X-Over factory-error correction

These instructions are for the Blade IV 6.5m and 8.5m. They apply to a small quantity of the first batch of kites.

fig.1
incorrect

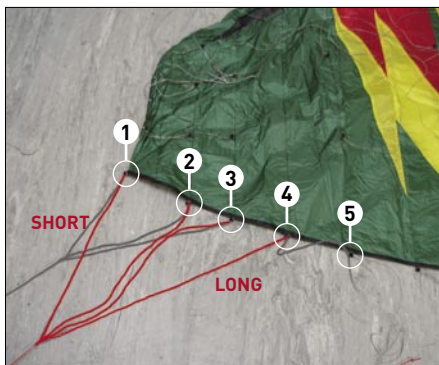
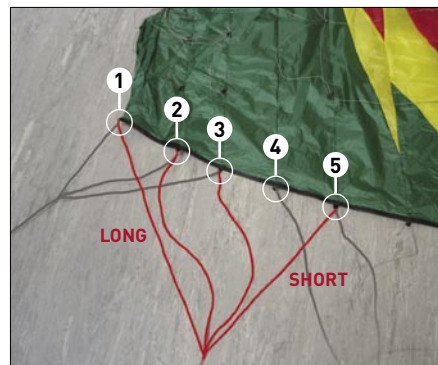
Problem: The primary lines on the X-Over have been mis-connected to the kite.

How to check if your kite is affected: To see if your kite is affected, you need to look at the coloured bridle lines that attach to the wingtips of your kite. Check that this cluster of four coloured lines is arranged with the longest line at the wingtip, and the shortest line towards the centre. If this is not the case you need to follow the instructions below to correct the issue, or you can send your kite back to Flexifoil and we will do it for you.

How this affects the flying of the kite: Once the X-Over Bridle is attached correctly you will notice the kite turns faster, keeps more power in the turns and is more stable. Also note that you can adjust the tension in the X-Over, to vary the turning speed of the kite. You can then set up the kites exactly to your liking!

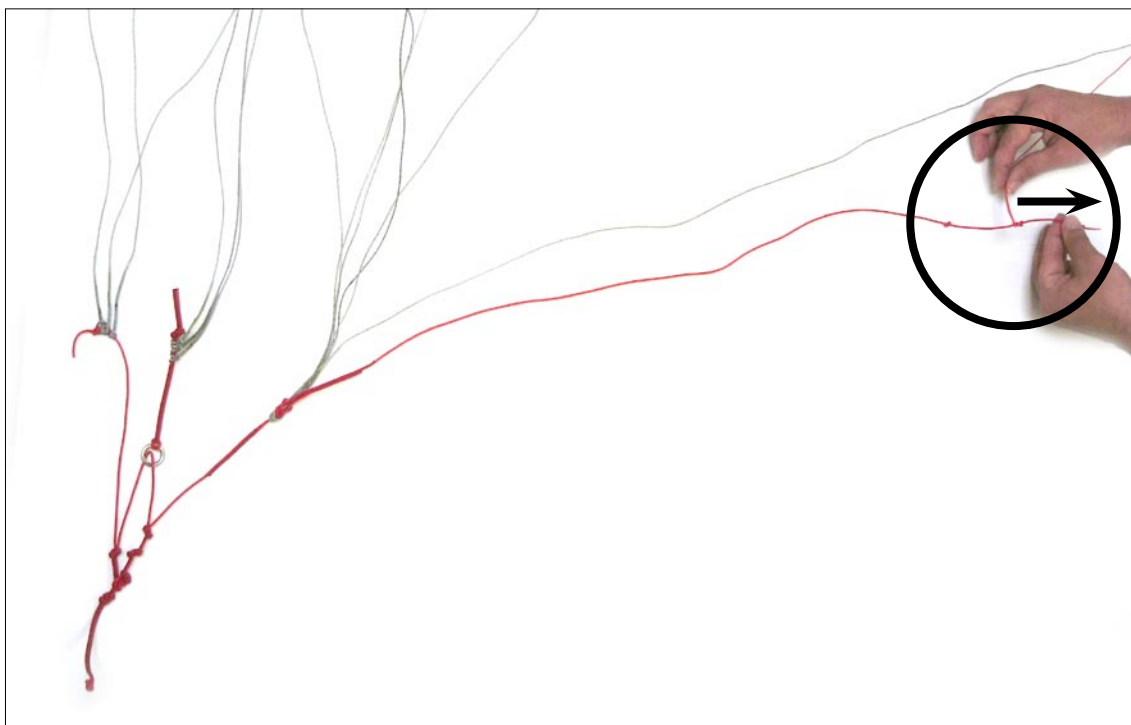
1. Unfold your kite in a large area
2. Carefully lay out the bridle, so that the main part of the bridle is above the kite, and the brakes below the kite.
3. Remove the left hand X-Over line from the X-Over adjuster

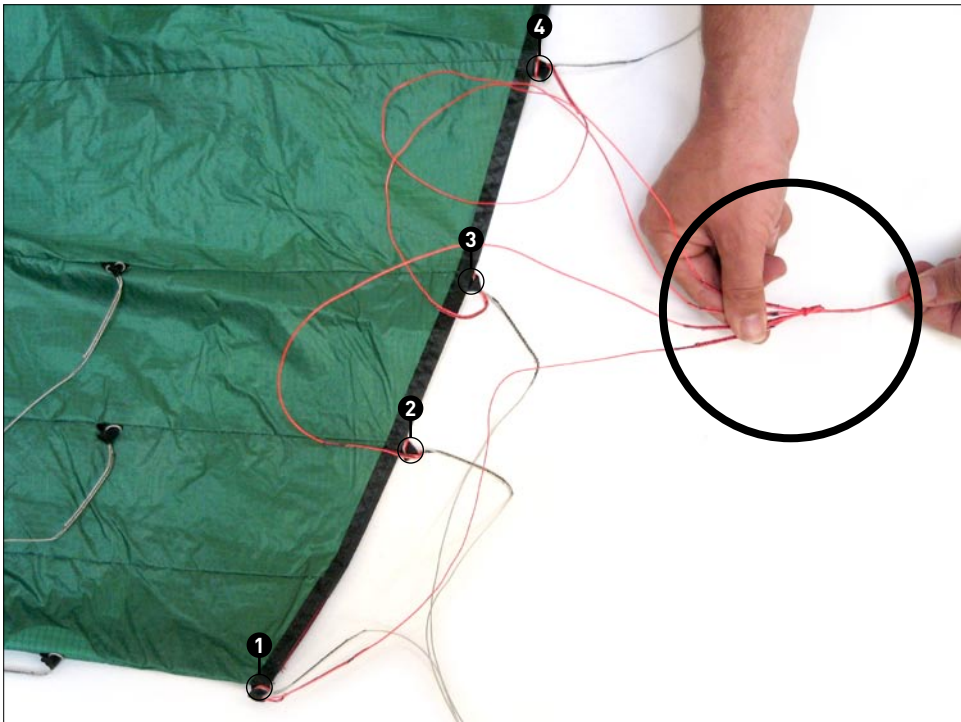
4. Carefully unthread the X-Over line through the guide ring.

5. Un-larks head the X-Over line from the four primary cross bridle lines.

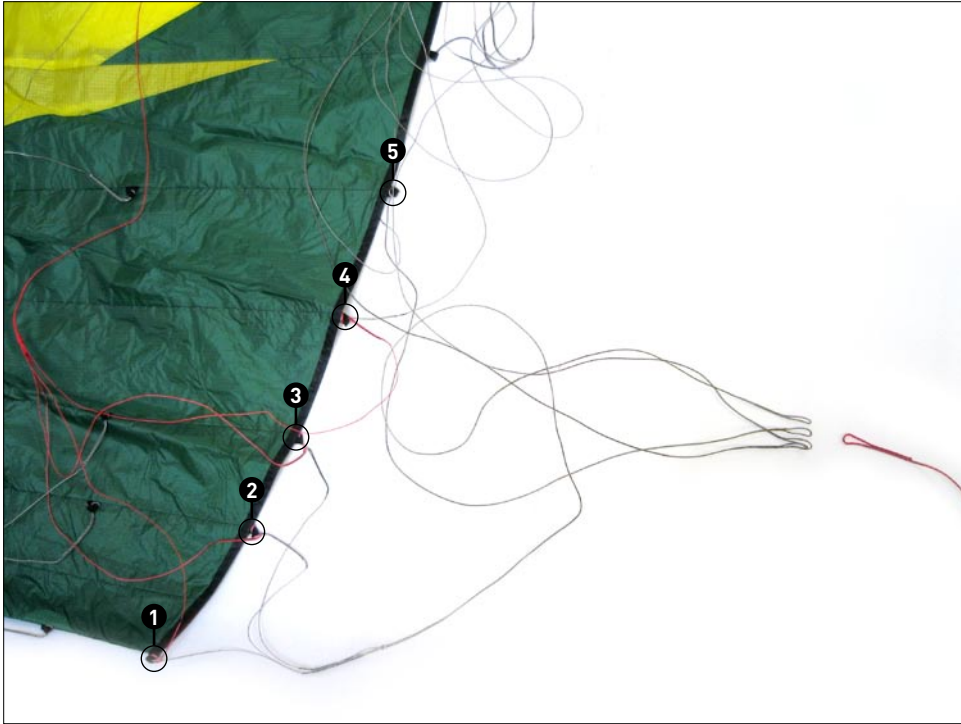
6. Remove the all four red primary lines from tabs 1, 2, 3 and 4.

- 7. NOTE:** It is possible that these lines have been threaded through the grey brake bridles and are impossible to remove easily. If this is the case you need to:
- Un-larkshead the brake leader from the four secondary grey brake bridles.

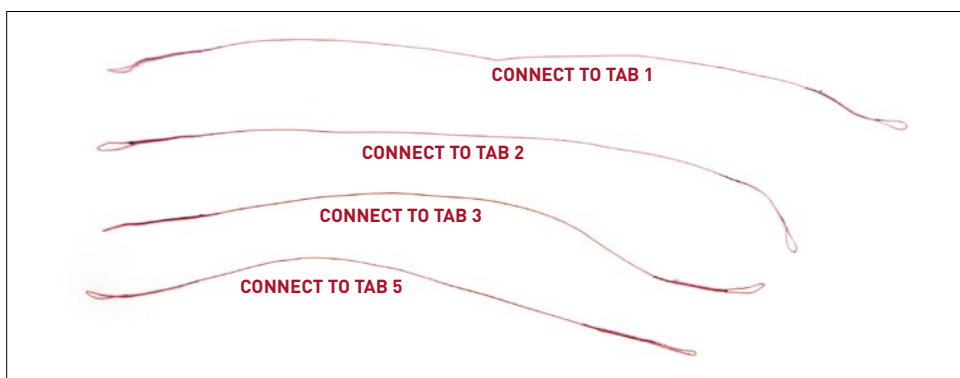
- Un-larkshead the wingtip grey secondary brake bridle line from the primary brake bridle line.
 - The red X-Over brake primary lines should now be easy to remove
 - Reconnect the grey brake lines. Reconnect as per **fig. 2** on the first page of these instructions.
- 8.** Connect the red X-Over brake primary lines to tabs 1, 2, 3 and 5 (as per **fig. 2** on the first page of these instructions) with the longest line at the wingtip, moving to the shortest line at tab 5 (see below).

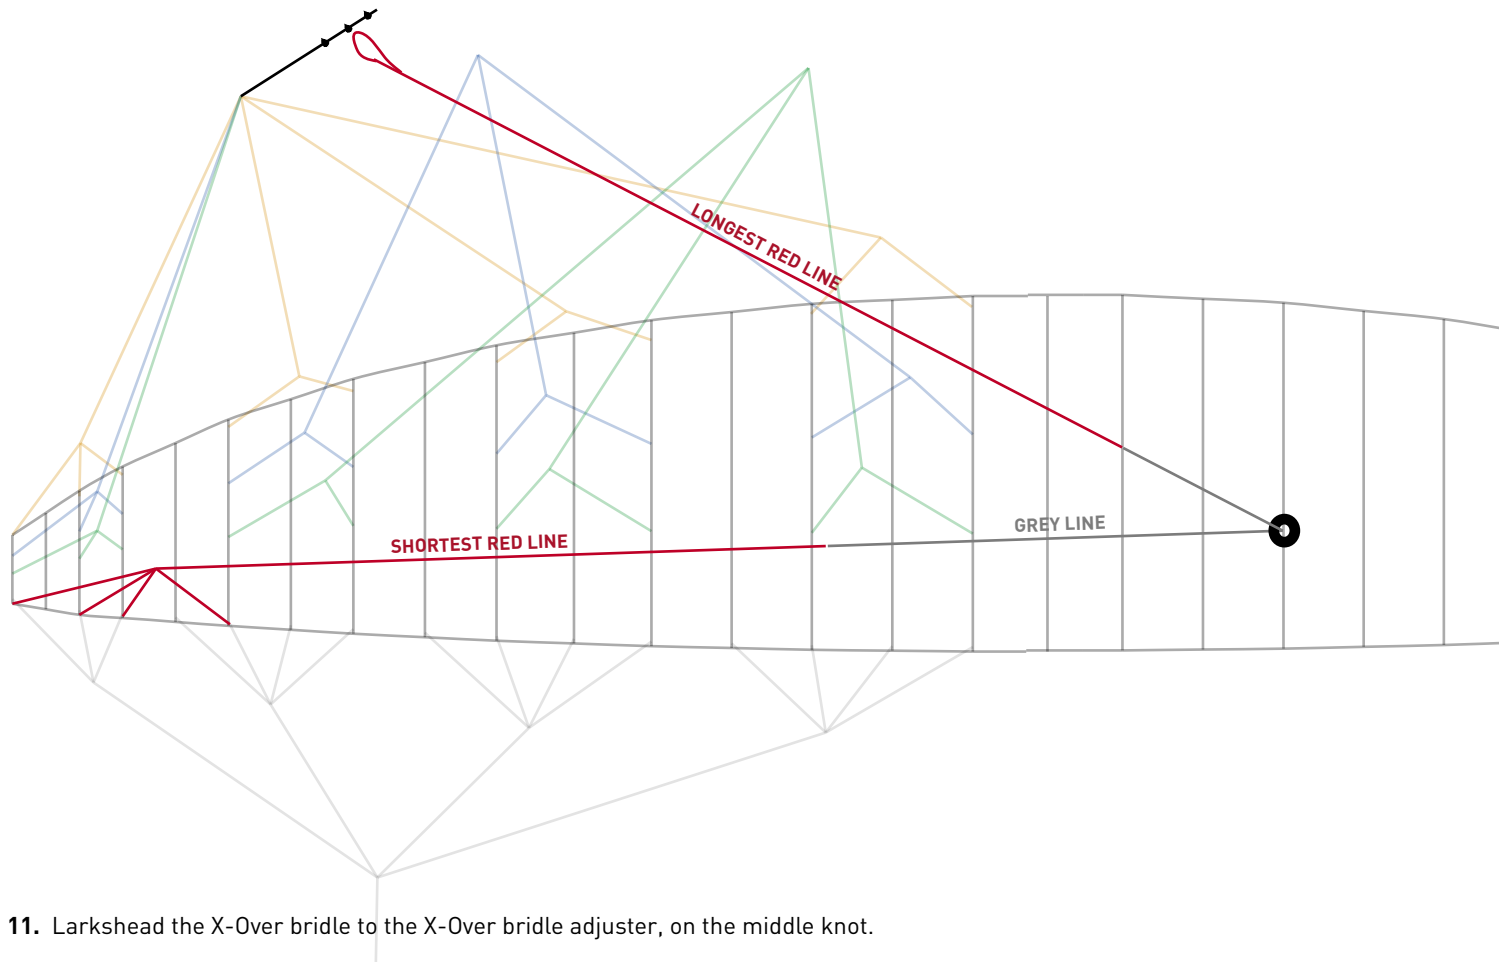
9. Reconnect the four red X-Over brake primary lines to the long X-Over Line.

10. Thread the other end of the cross line through the guide ring on the opposite side of the kite. When doing this it is important to guide the X-Over line between the main section of the bridle and the brake section of the bridle. **Note: the shortest coloured section connects closest to the kite bridle, the longest section connects to the Triple A Bridle Adjuster, allowing the grey section to run freely through the guide ring.**
